STAFF REPORT

SUBJECT: H-2021-0087
Apex West – PP (aka Pinnacle)

LOCATION: North side of E. Lake Hazel Rd.,
approximately 1/4 mile west of S. Locust
Grove Rd., in the south 1/2 of Section 31,
T.3N., R.1E.

A. Preliminary Plat & Phasing Plan (date: ~~8/16/2021~~ 3/16/2022) – REVISED

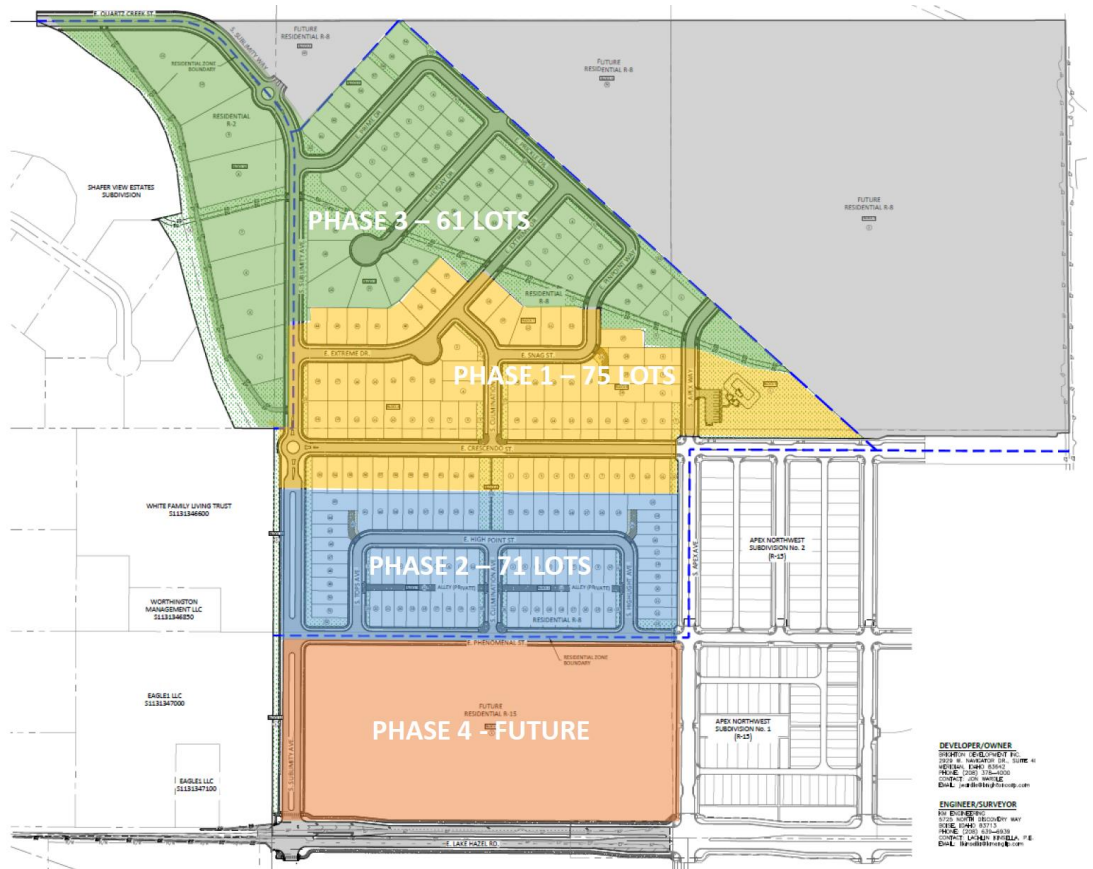
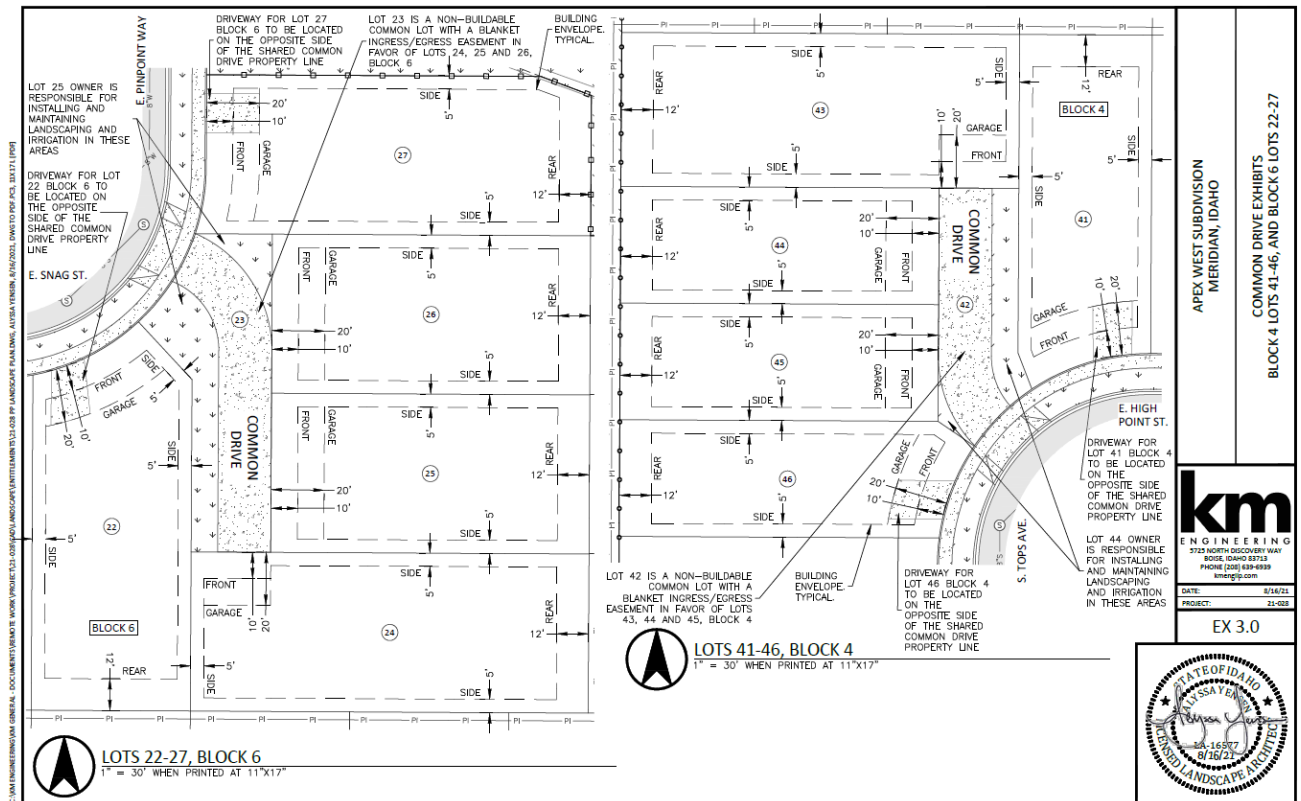
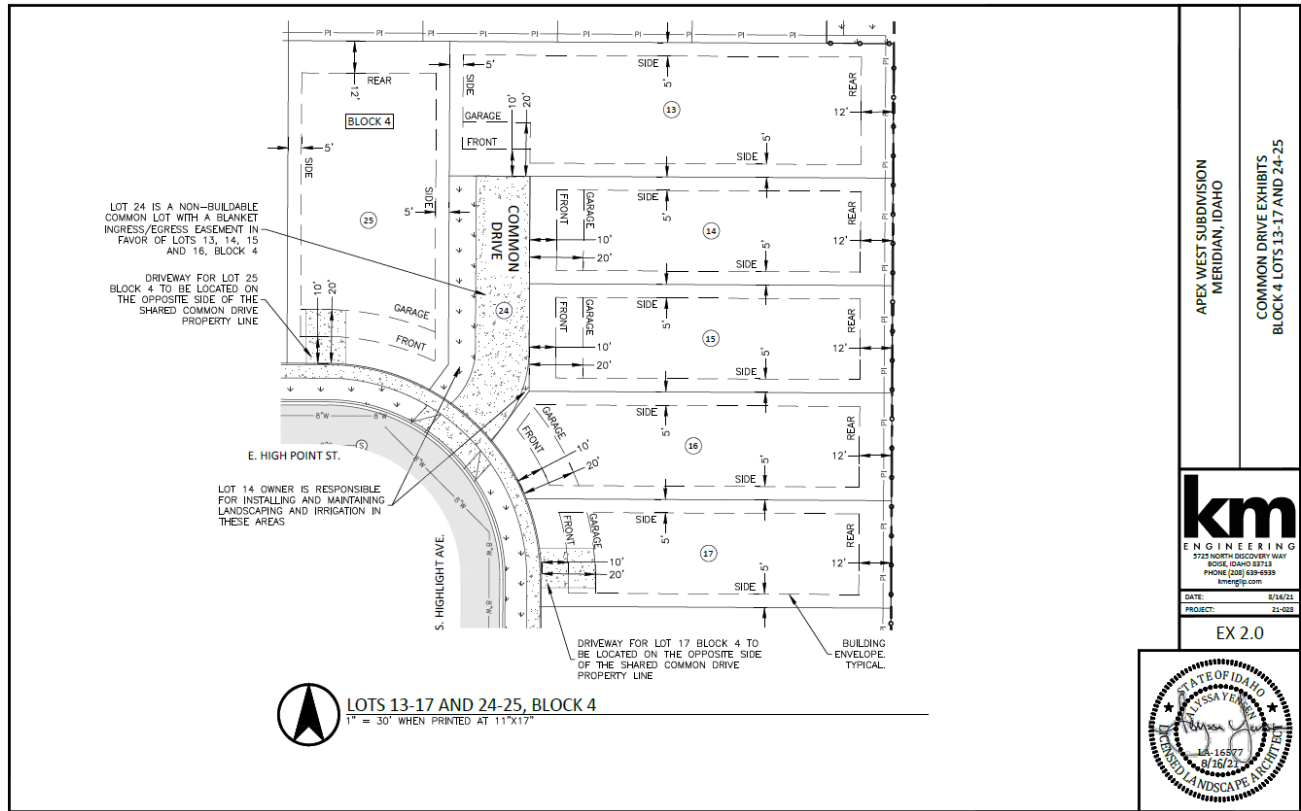
The subdivision is proposed to develop in ~~four~~ five (4 5) phases as shown on the phasing plan in Section VII.A.

Three ~~Four~~ future development areas are depicted on the plat, Lots 32 and 43, Block 6; Lot 2, Block 5; and Lot 1, Block 1. The R-8 zoned lots (i.e. Lots 32 and 43, Block 6; and Lot 2, Block 5) are planned to be re-subdivided in the future through new preliminary plat applications. The R-15 zoned lot (i.e. Lot 1, Block 1) may be re-subdivided in the future through a new preliminary plat application for the development of 240 townhomes; or, a multi-family development may develop on the site, which will require approval of a conditional use permit. **If single-family homes or townhomes are developed on these lots, they shall be re-subdivided prior to issuance of any building permits.**

B. Common Driveway Exhibits

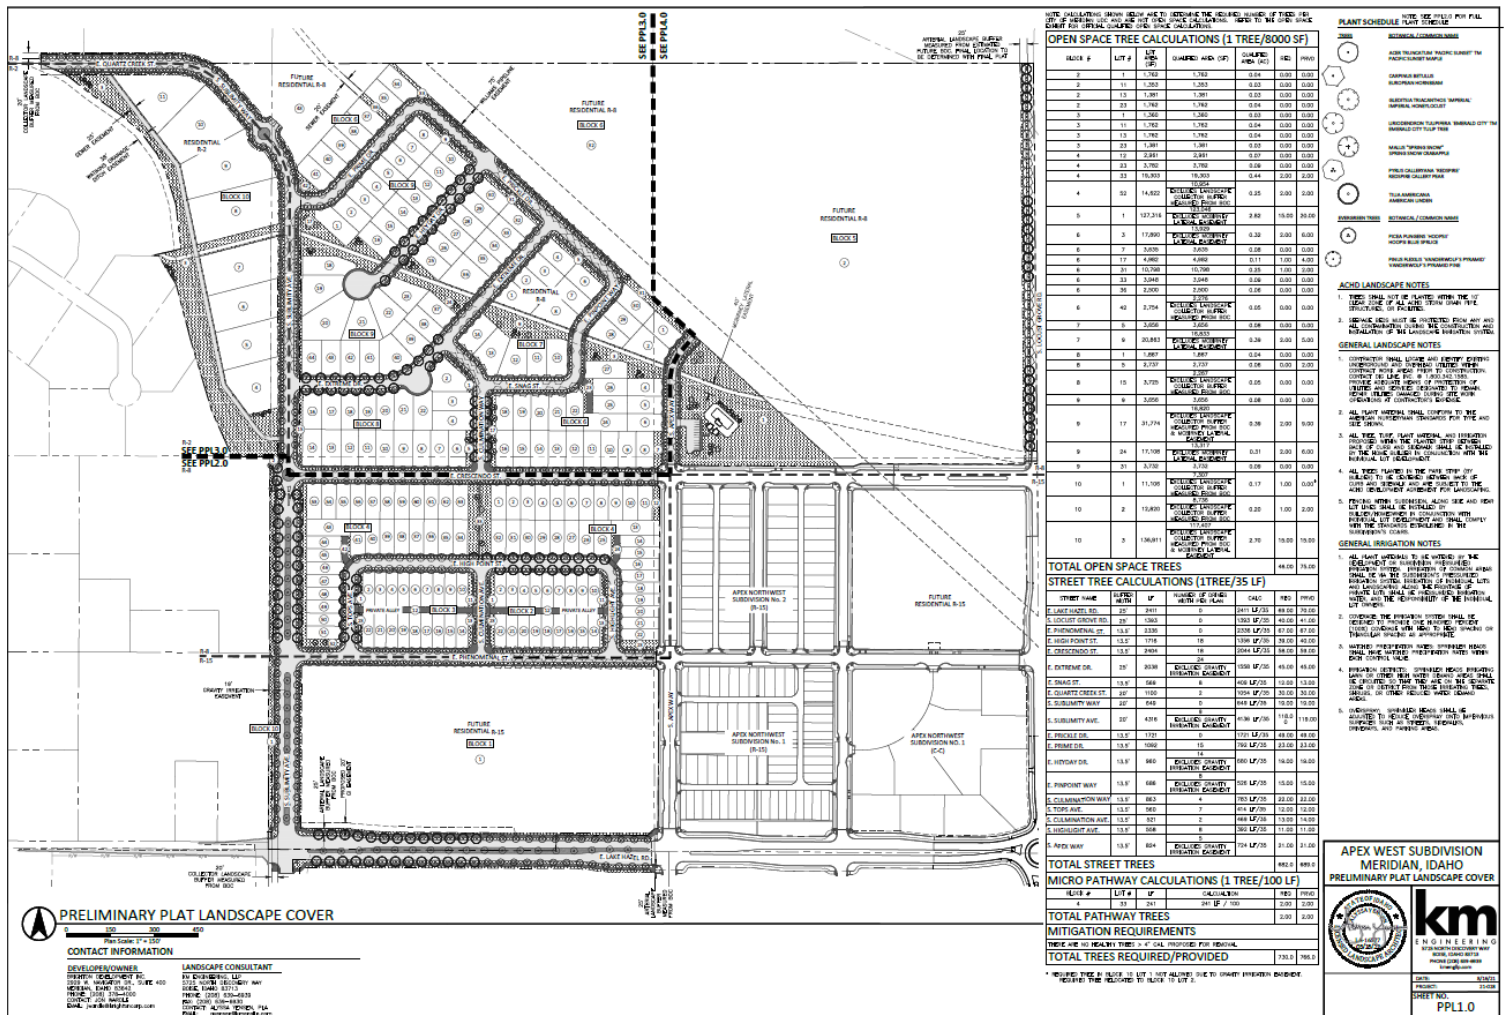
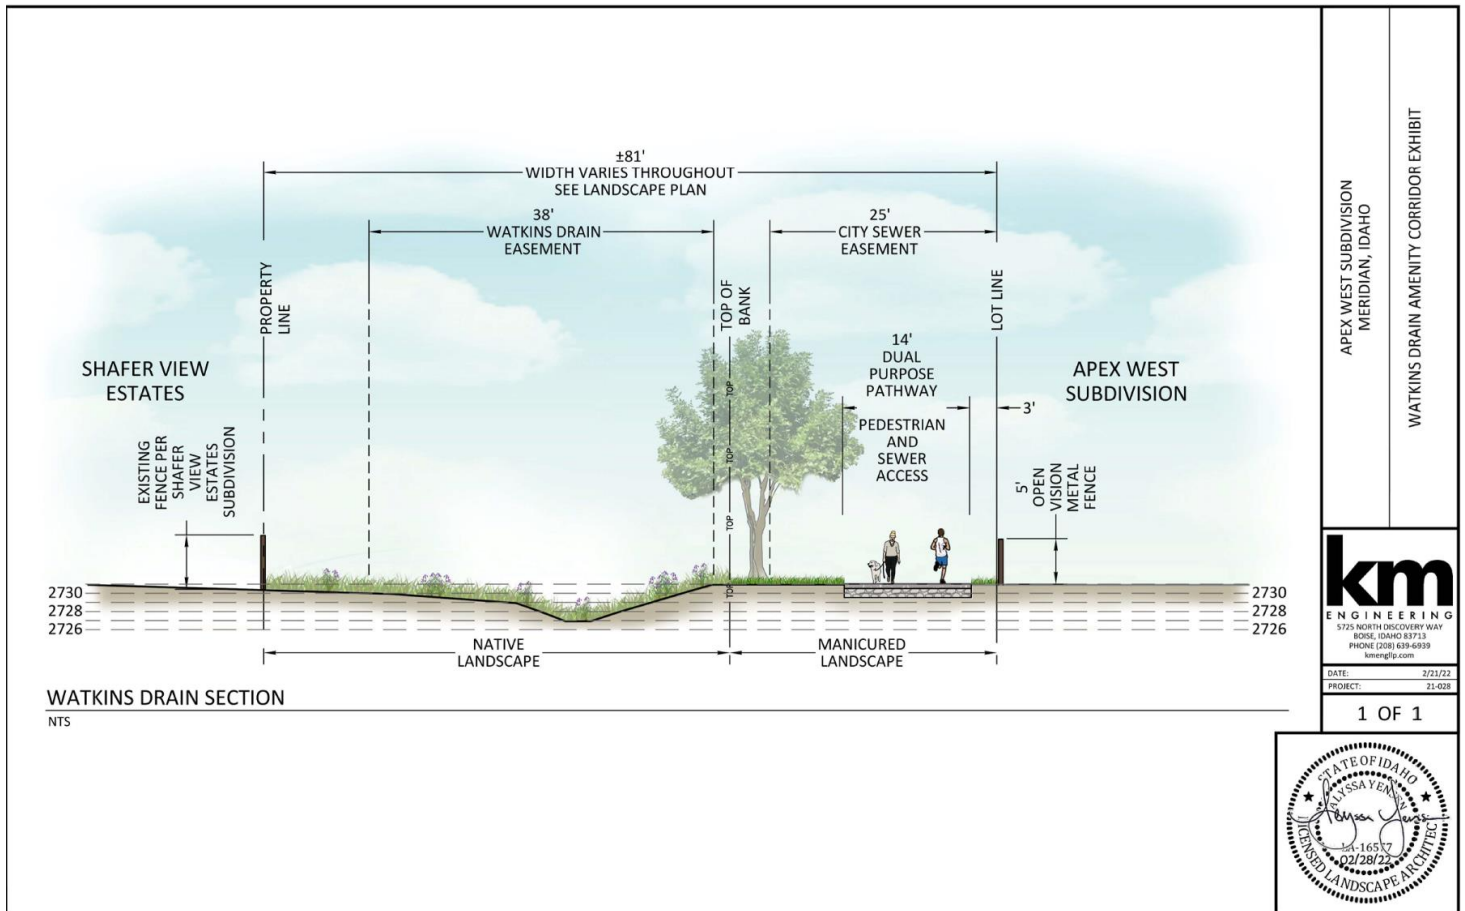
Public alleys are proposed for internal access to some of the lots in Phase 1; alleys are required to comply with the standards listed in UDC [11-6C-3B.5](#). Three (3) common driveway lots are also proposed and are required to comply with the standards listed in UDC [11-6C-3D](#); an exhibit for such is included in Section VII.B.

C. Landscape Plan & Fencing Plan (date: ~~8/16/2021~~ 3/15/2022) - REVISED

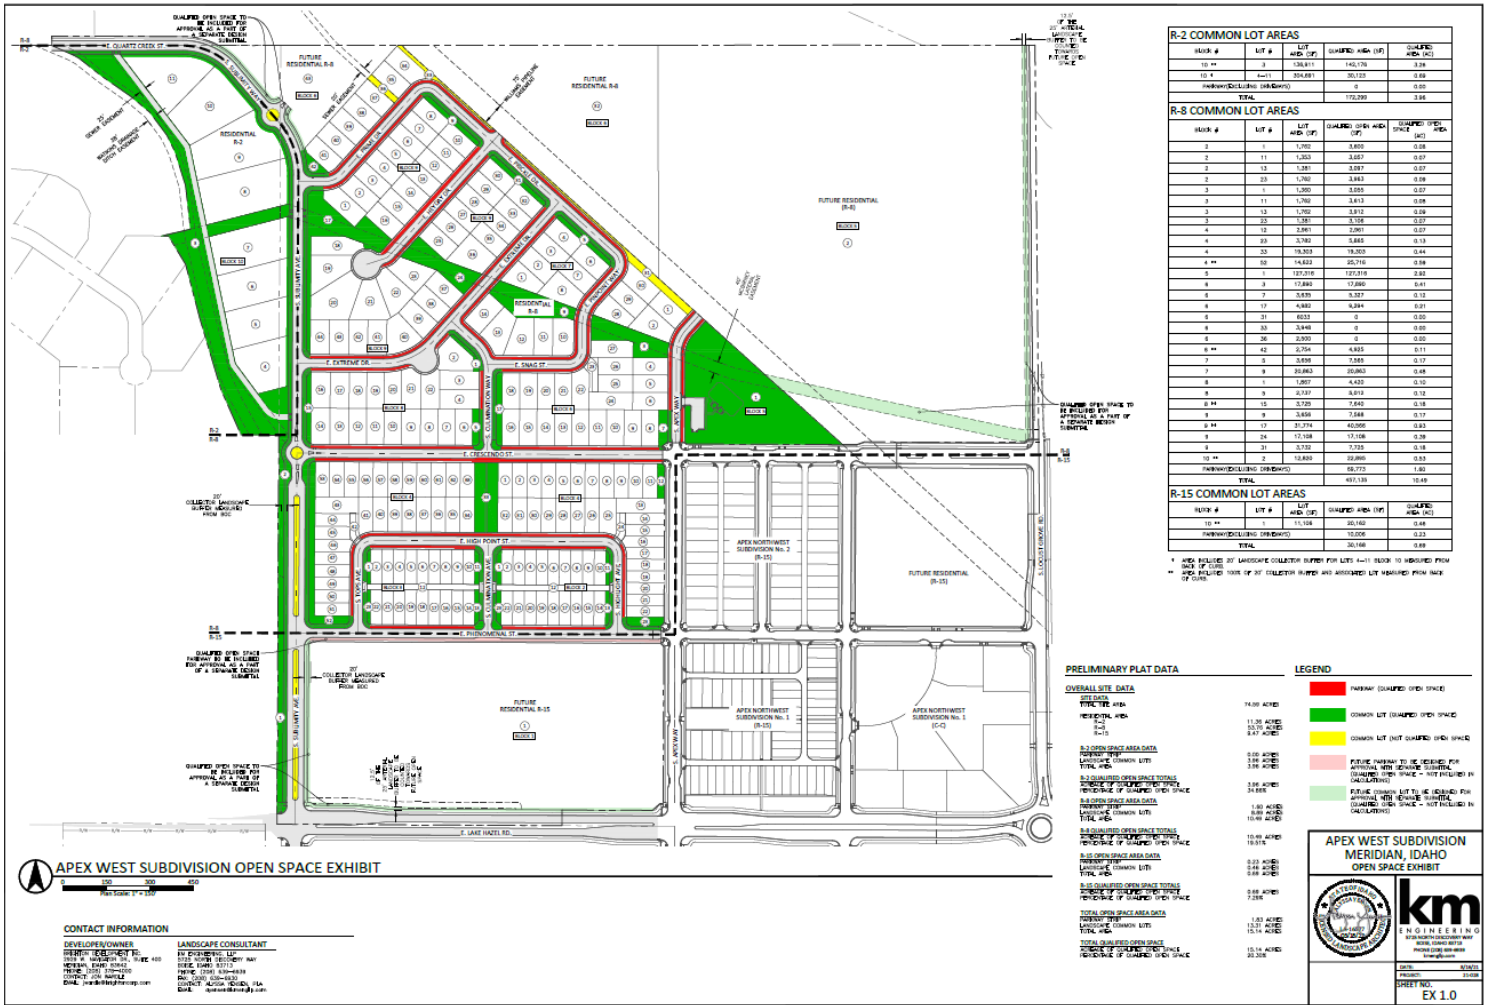
- e. A minimum 5-foot wide pathway shall be included in Lot 36, Block 6.
 - f. Depict a 10-foot wide detached multi-use pathway along the west side of S. Sublimity Ave. as required by the Park's Dept. in accord with the Pathways Master Plan.

- g. The fencing on the northeast side of Lot 34, Block 6 shall be revised to comply with the standards listed in UDC 11-3A-7A.7b.
4. A 14-foot wide public use easement shall be submitted to the Planning Division for the multi-use pathways within the site that are not within the public right-of-way prior to submittal of the final plat for City Engineer signature in the phase in which they are located.
